M2PP-121-D-PLNM-0008

Site Specific Management Plan 008 - [sectors 480/510]
MacKays to Peka Peka Expressway

31 MARCH 2015 - REV C - CERTIFIED ISSUE

SITE SPECIFIC MANAGEMENT PLAN - TE MOANA [SSMP 8 - SECTOR 480, 510]

CS5 - CROSS SECTIONAL ELEVATION - TE MOANA ROAD BRIDGE

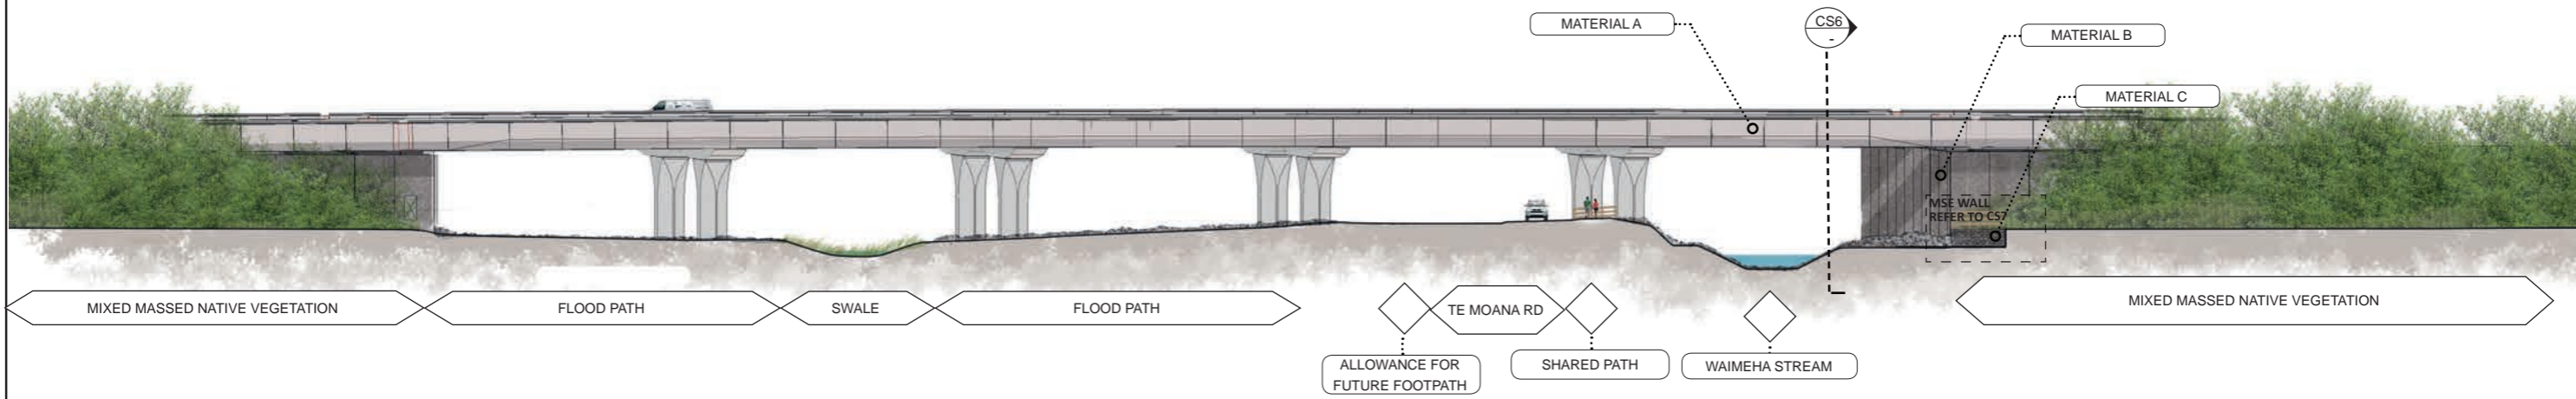
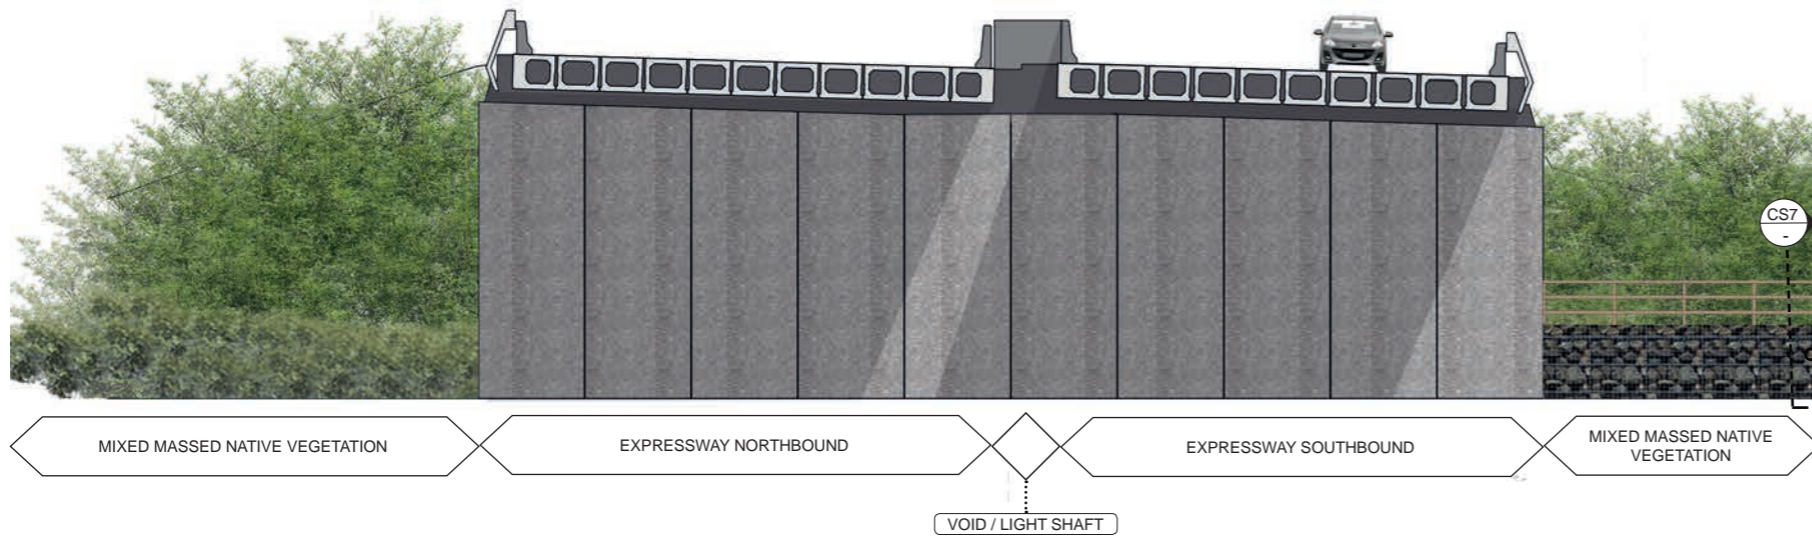
<p>CS6 is labelled South abutment but actually shows northern abutment (check northbound and southbound traffic on cross-section).</p> <p>CS7 – Waimeha Stream – cross-section should be a mirror image (in terms of location of x-section line on Sheet 7).</p> <p>What does timber guard rail look like in elevation?</p> <p>Would like detail re the design of the fence along the northern edge of Te Moana Rd footpath and under the Te Moana bridge next to the riprap. Is it the same as the guardrail above? How will this section of the footpath look for local pedestrians?</p>	Sheet 9	<p>Label amended</p> <p>Cross section reference marker on sheet 7 rotated to accurately reflect cross section direction</p> <p>Elevation of guard rail provided on sheet 9</p> <p>Extent of fence made clearer on sheets 7 and 8. Example of fence type introduced to sheet 9A</p>
		No detail provided of CWB entry at Kauri Road (typical Type 2 detail) for resident consultation.	Sheet 11	This CWB intersection is covered by SSMP 7. Refer SSMP7

Title: SSMP 8 [480-510] - SHEET 9
BRIDGE SECTIONS

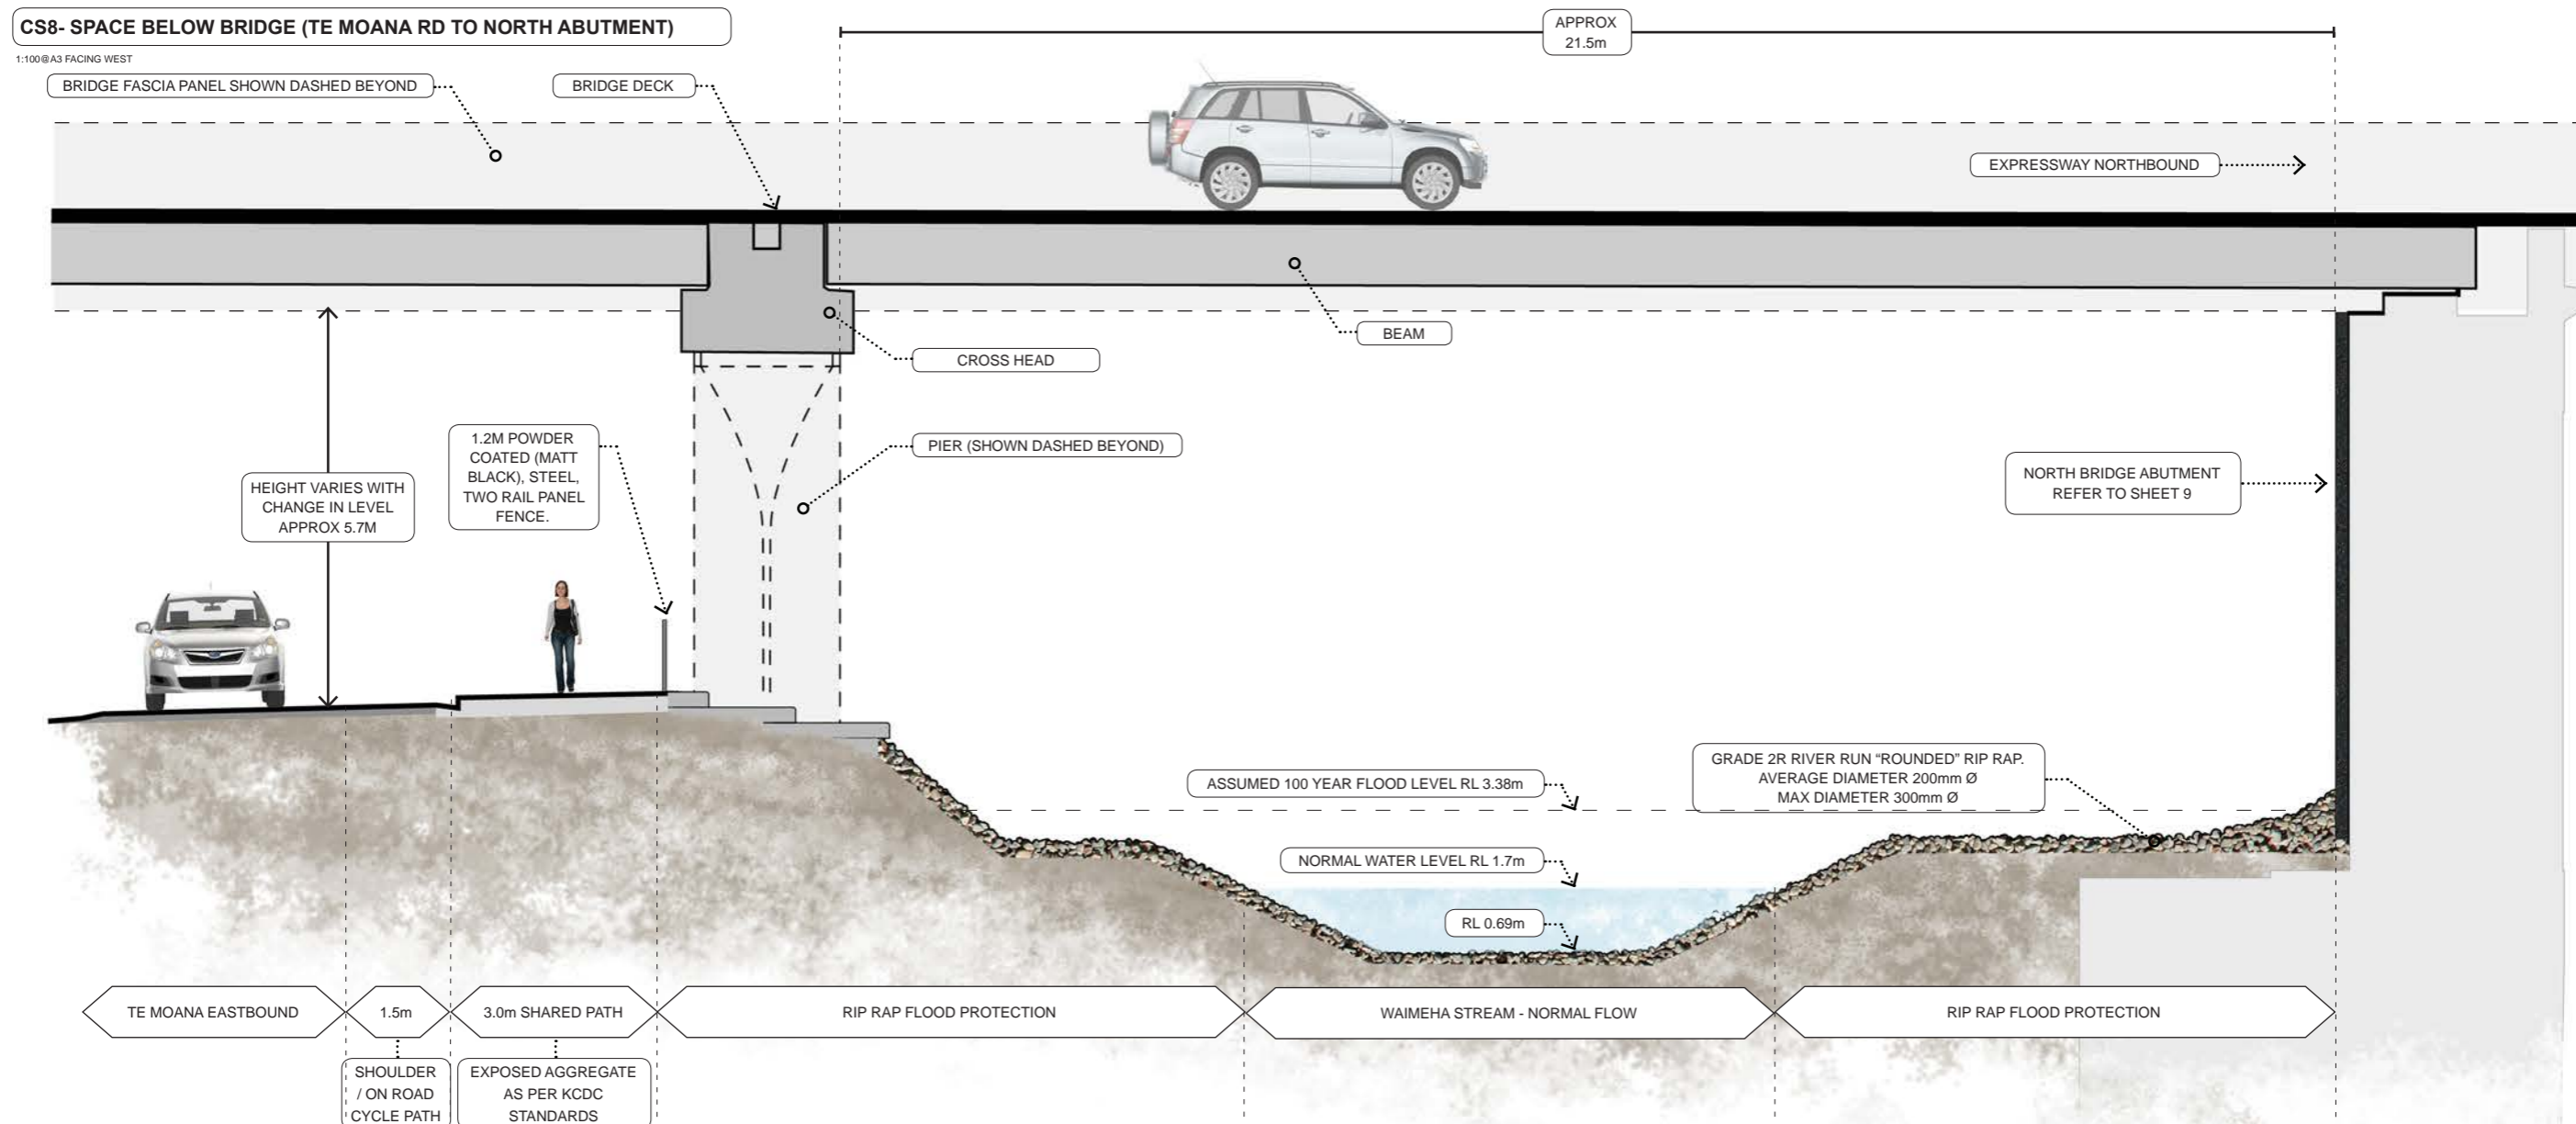
<p>E 'Bridge Abutments'</p> <ul style="list-style-type: none"> • Paragraph 2 - Description of abutment treatment doesn't match description on Sheet 9 • Last Paragraph – says architectural lighting will be provided under the bridge – this isn't clearly indicated in Appendix 3: Bridge Summary, ULDF principles summary/ under principle 7. See also comment under sheet 15 below. 	Text p.9 -	<p>The text description on sheet 9 is incorrect and has been inadvertently copied from the SSMP 3 (Kapiti bridge). The abutment will be finished with an exposed aggregate finish.</p> <p>Architectural lighting to be used to add additional interest and safety at night.</p> <p>Softly up light the 4 columns (the two either side of Te Moana Road) to accentuate the form of the columns.</p>

Title: SSMP 8 [480-510] - SHEET 9A
SECTION BELOW BRIDGE

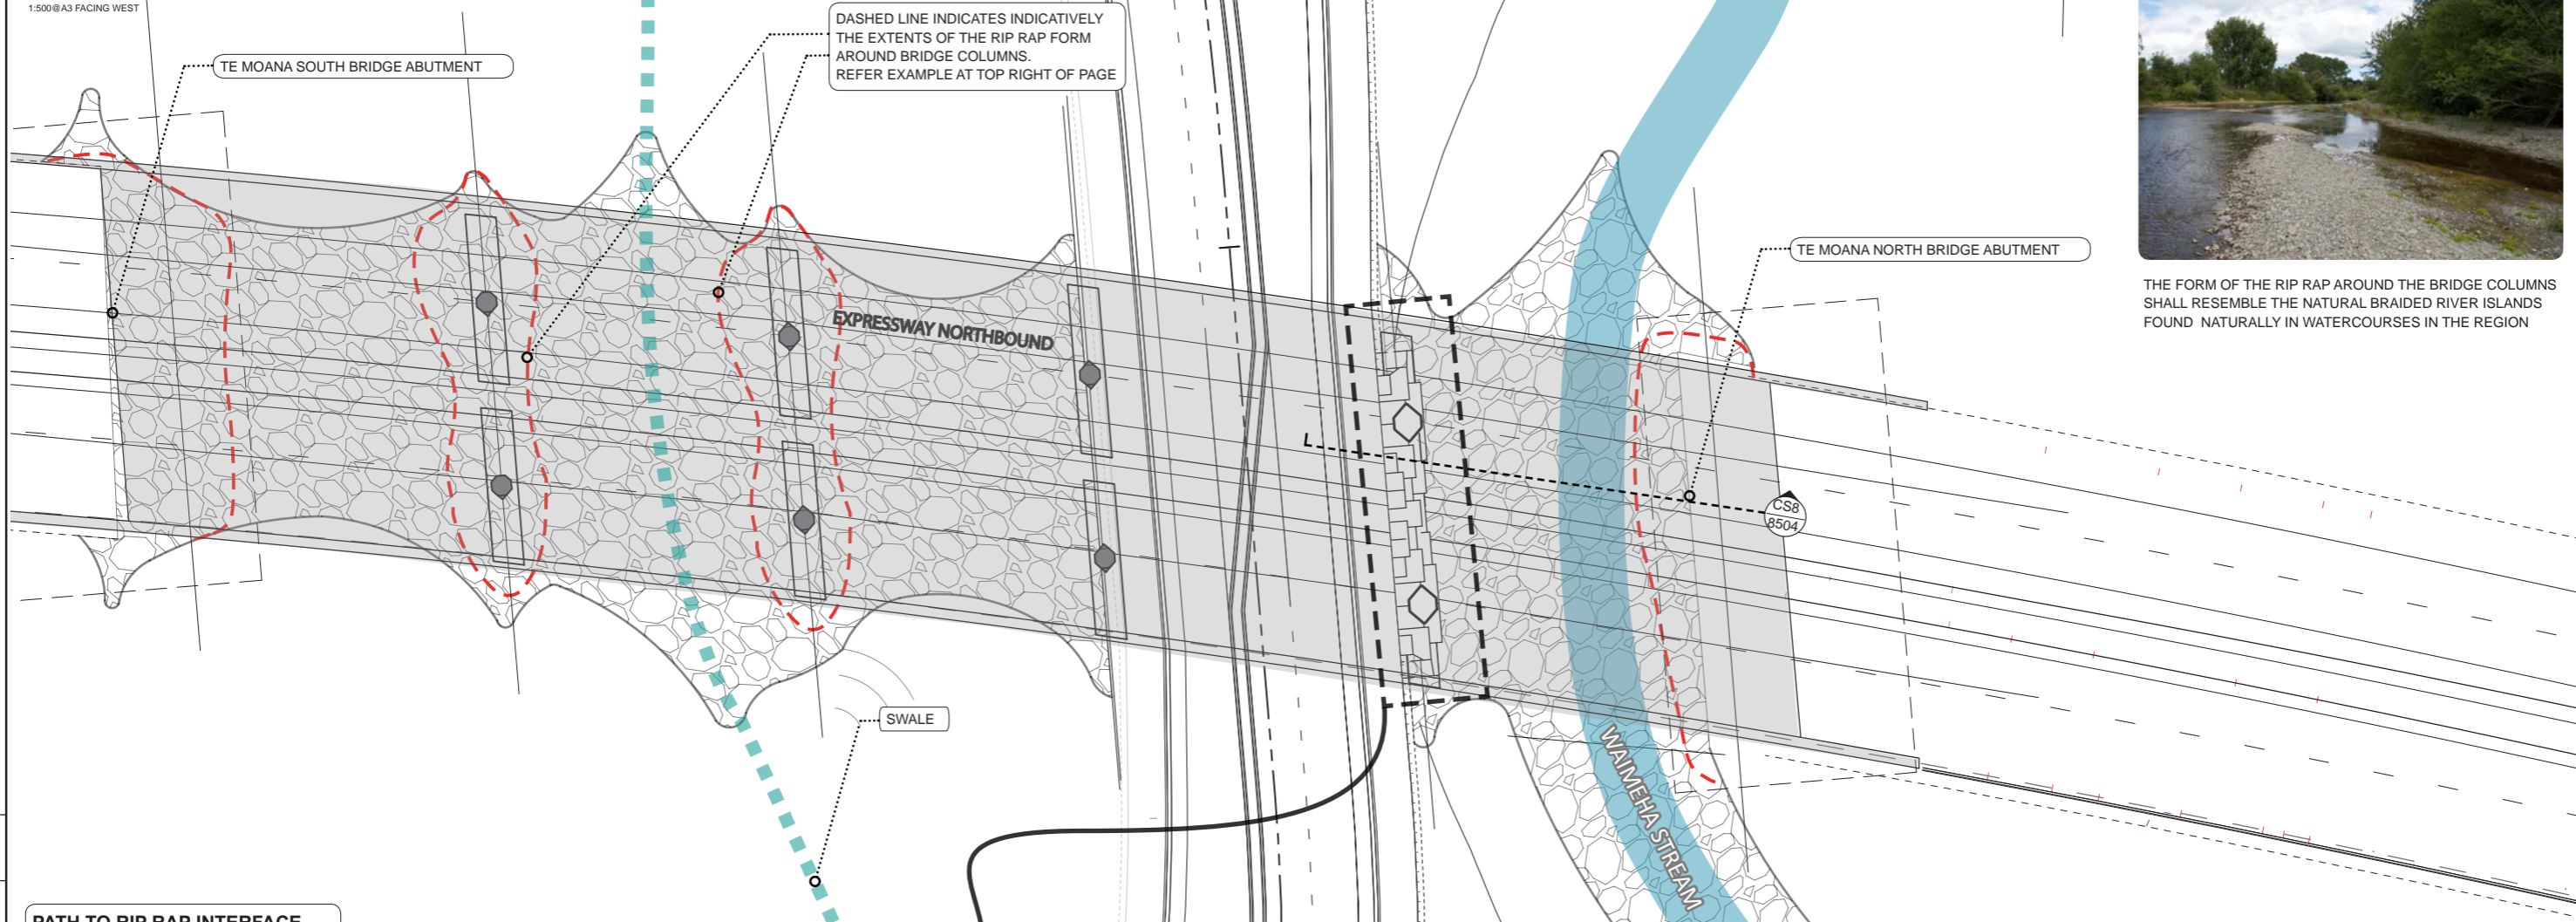
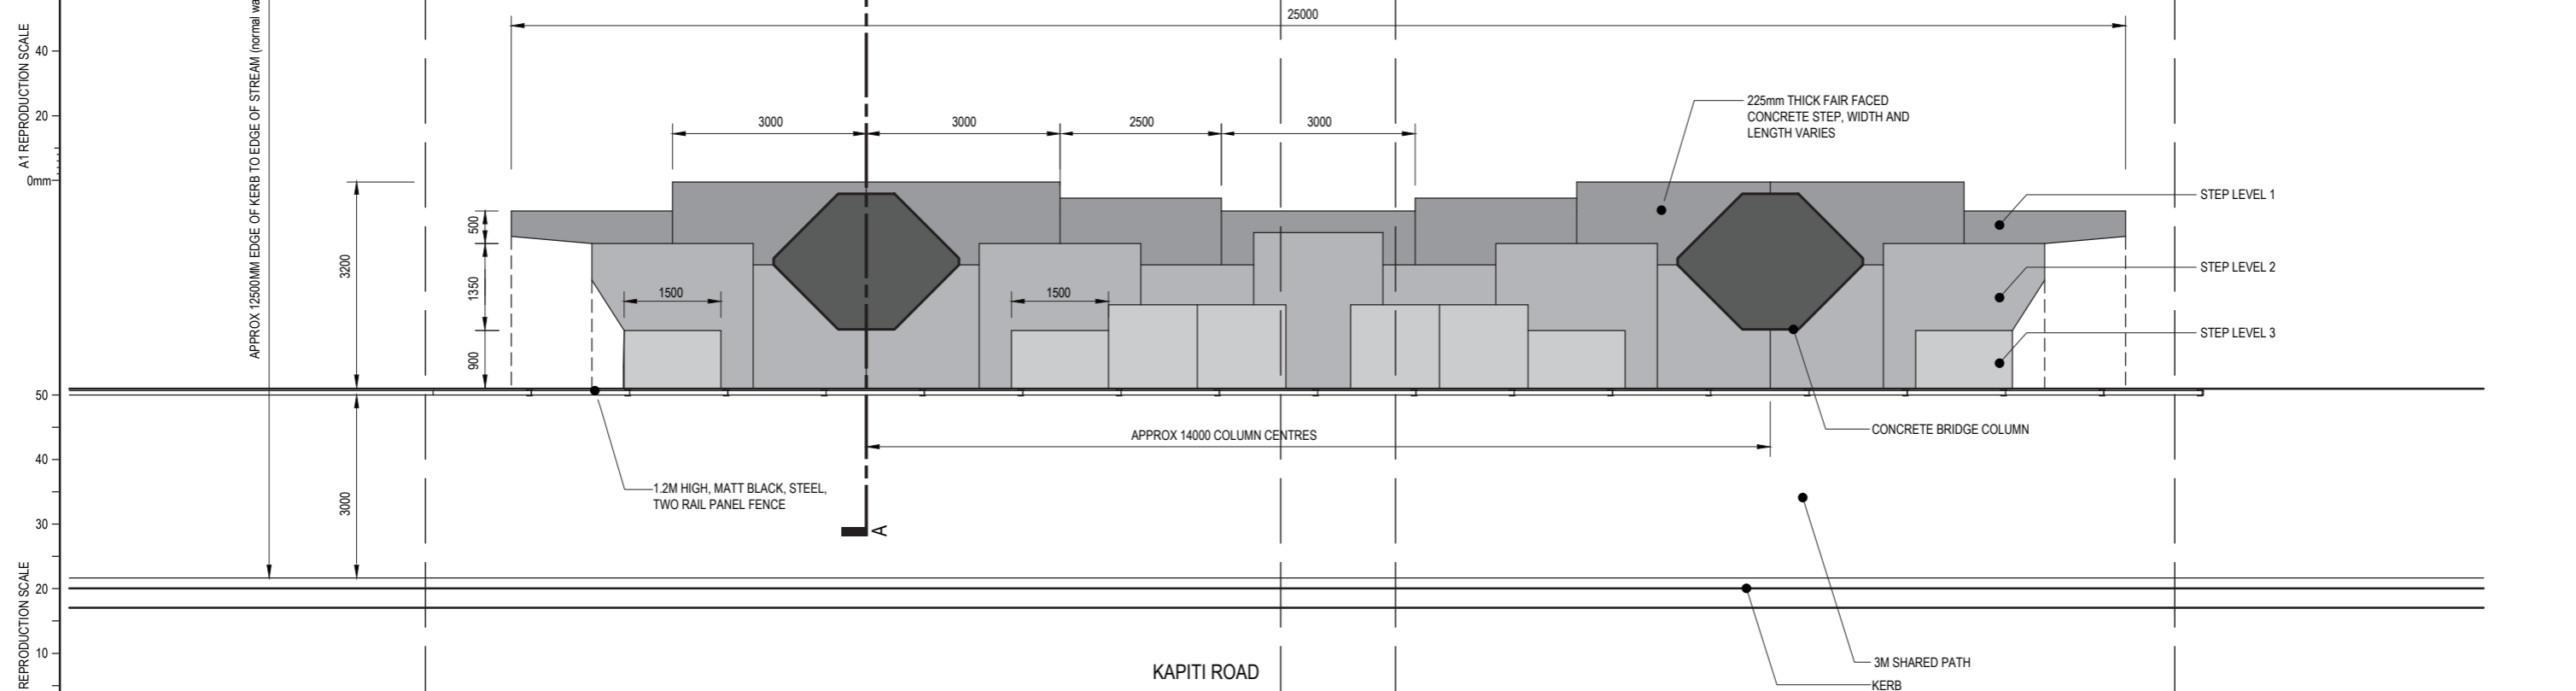
18/12/2014	Email	JW, DP	Interface between Te Moana Road Footpath and Riprap: The design of the interface between the footpath and the hard surface on the stream bank. It is unclear whether the riprap extends to the footpath, or whether the flatter berm between the footpath and stream bank is gravelled, and how the transition between materials is handled.	Sheet 9A, 9B	A series of 225mm precast concrete slab 'sculptural' steps (3 levels) create a visual transition between the Te Moana Road shared path and the riprap of the Waimeha Stream Bank. The sculptural steps create increased visual amenity and additional interest for users of the shared path. In some area the riprap will extend around the concrete steps and help the integration of the steps into streamside/bank landscape.
